Subject: CHECK ENGINE LIGHT ON WITH DTC P0456	Bulletin No: 01-008/15
	Last Issued: 05/15/2015

- This bulletin supersedes the previous bulletin 01-014/14, issued on 06/10/2014. The APPLICABLE MODEL(S)/VINS have been revised.
- Changes are noted below in Red beside the change bar.

2011-13 MAZDA3, 2007-14 CX-9:

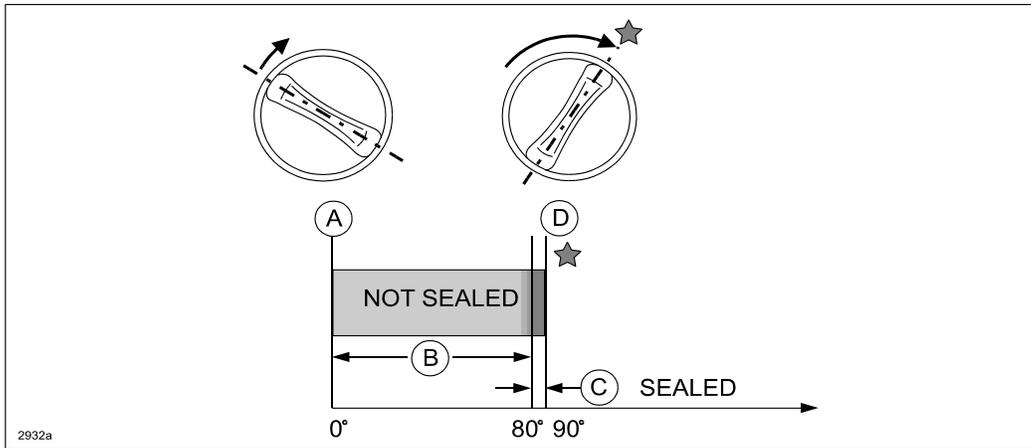
- **DO NOT** replace any parts without detecting a leak using MS3 / Workshop Manual diagnostics.
- **Explain to the customer that the fuel cap must be turned at least 80 degrees (C) or until two (2) or more click sounds are heard (D) to be properly sealed.**
- If the fuel cap is not completely closed, it may stay in the B range, (because the C range is so small) and will likely leak.

2014-15 MAZDA3, 2013-16 CX-5, 2014-16 MAZDA6:

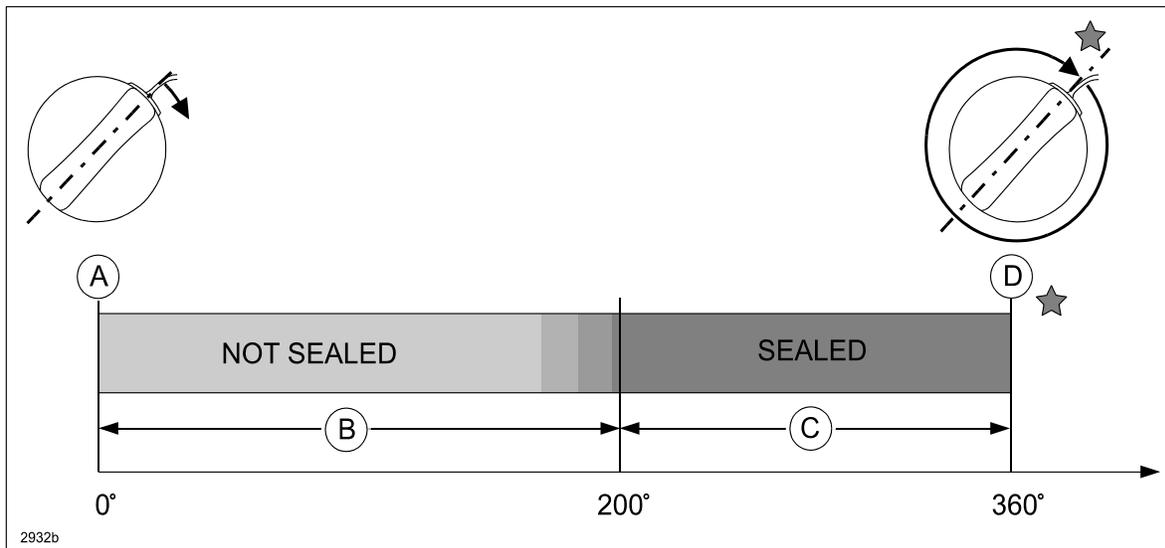
- If the fuel cap is turned less than 200 degrees (B), it is not sealed.
- If the fuel cap is turned between 200 ~ 360 degrees (C), it is sealed.
- If the fuel cap is turned 360 degrees or more, it is sealed and a clicking noise (D) is also heard.

NOTE: The fuel cap may stay within the (C) range, since it is a large range. A leak is unlikely to occur, even if the fuel cap was not closed completely (until clicking sound is heard (D)).
